Re: Beazer Monitoring Well HG-29D
Cabot Carbon/Koppers Superfund Site, Gainesville, Florida

On behalf of Cabot Corporation (Cabot), this letter responds to Tetra Tech's October 13, 2015 letter regarding the plugging and abandonment of Beazer's monitoring well, HG-29D. In their letter, Tetra Tech chooses not to address the groundwater quality temporal trend observed at HG-29D, the most important indicator of well seal leakage, and argues that the construction of the monitoring well did not have to satisfy the United States Environmental Protection Agency (US EPA) and Florida Department of Environmental Protection (FL DEP) requirements for monitoring well construction. As discussed below, groundwater quality clearly demonstrate that monitoring well HG-29D is leaking and needs to be plugged and abandoned. US EPA and the other stakeholders had agreed that plugging and abandonment of the monitoring well was appropriate based on discussions in the July 2014 meeting in Gainesville and in subsequent conference calls.

FIGURE 1

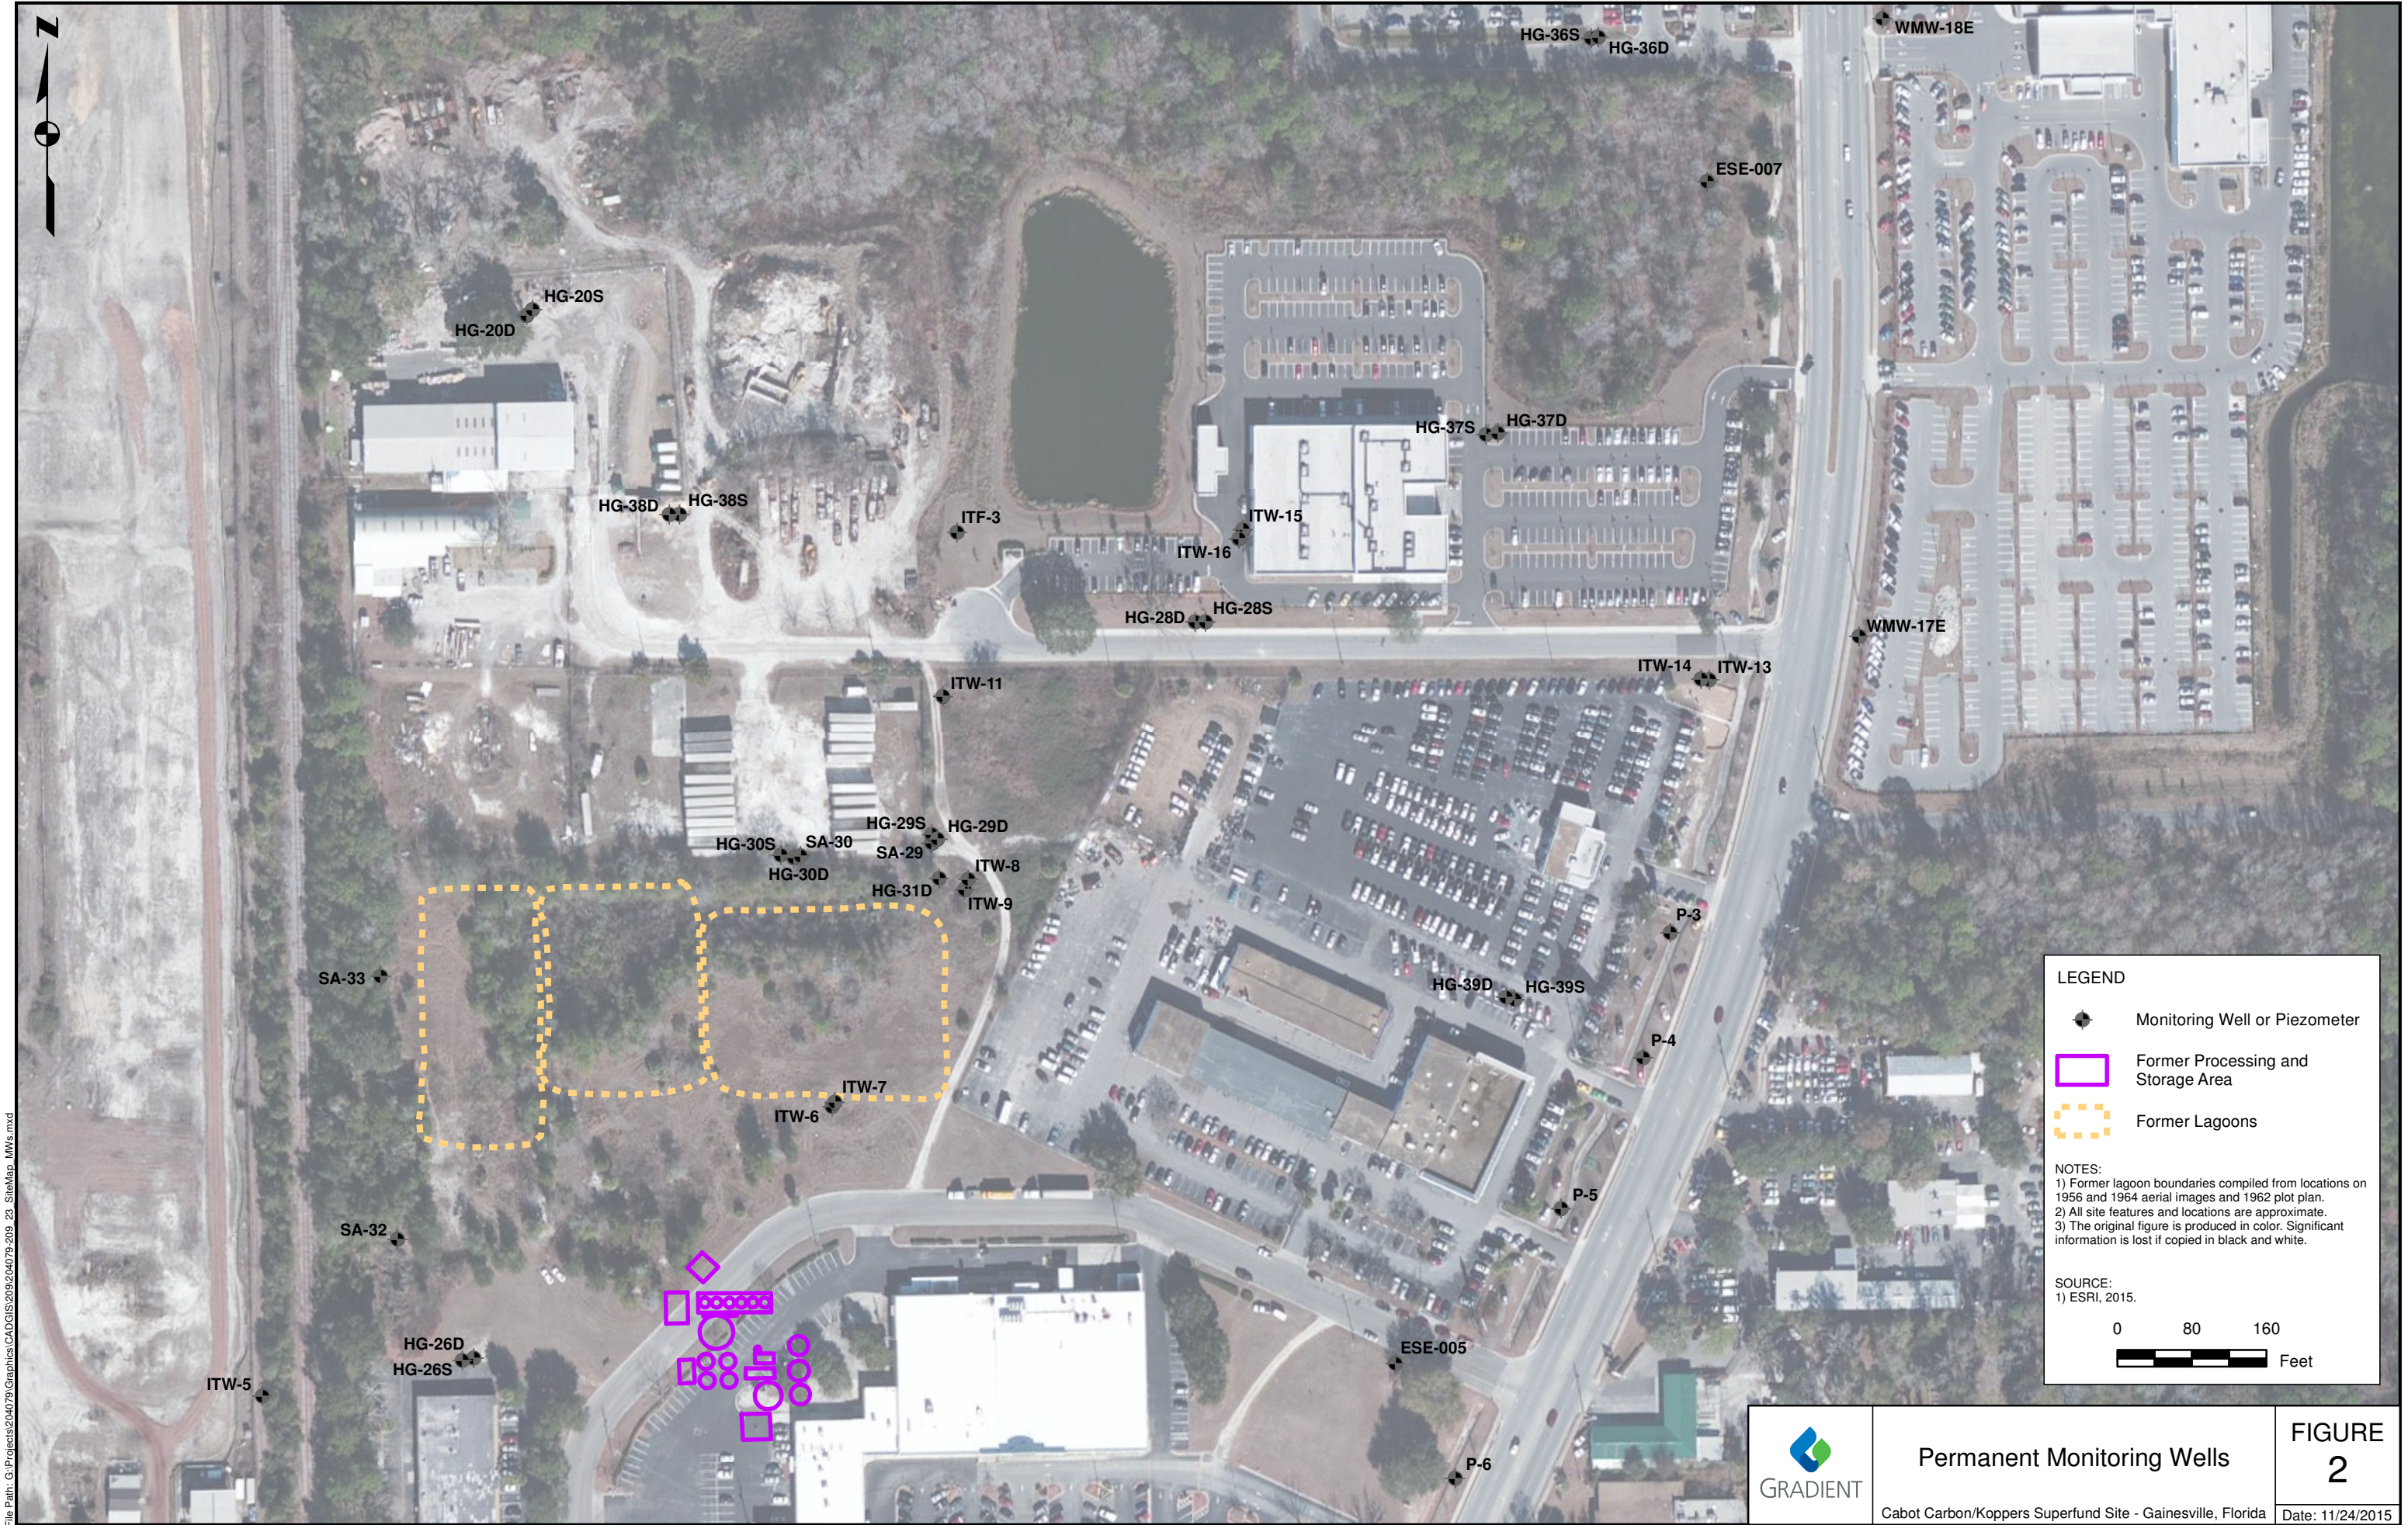
Groundwater concentrations for key pine processing compounds (*e.g.*, phenol, 3,4-methylphenol) at HG-29D have increased by more than order of magnitude and are now approaching concentrations observed in the paired Upper Hawthorn Group (UHG) monitoring well, HG-29S (Figure 1). In contrast, groundwater concentrations at the other LHG monitoring wells near and/or downgradient of the former Cabot lagoons (HG-30D, HG-31D, and HG-28D; Figure 2) are much lower and are stable. In fact, monitoring well HG-31D was installed immediately upgradient of HG-29D, and as close to the former Cabot lagoons as possible, with the sole purpose of replacing the compromised well (HG-29D). Groundwater concentrations at this replacement well continue to be significantly lower than at HG-29D (Figure 1). This difference in both the magnitude of observed groundwater concentrations and the difference in the temporal trend between the two monitoring wells, located less than 40 feet apart, is being caused by the leaking seal at HG-29D.
